Recall Bulletin

SUBJECT: Drivers Airbag Module Retention

MODELS: 2015 Chevrolet Corvette

GM Recall #14594

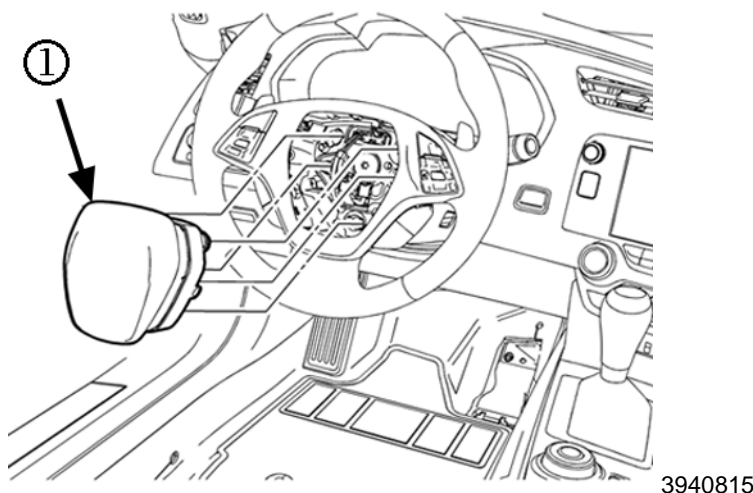
1. Remove the steering wheel airbag module (1). Refer to *Steering Wheel Airbag Replacement* in SI.
2. Install the new steering wheel airbag module. Refer to *Steering Wheel Airbag Replacement* in SI.

Dealers are to replace the Driver Airbag Module with a revised Driver Airbag Module.
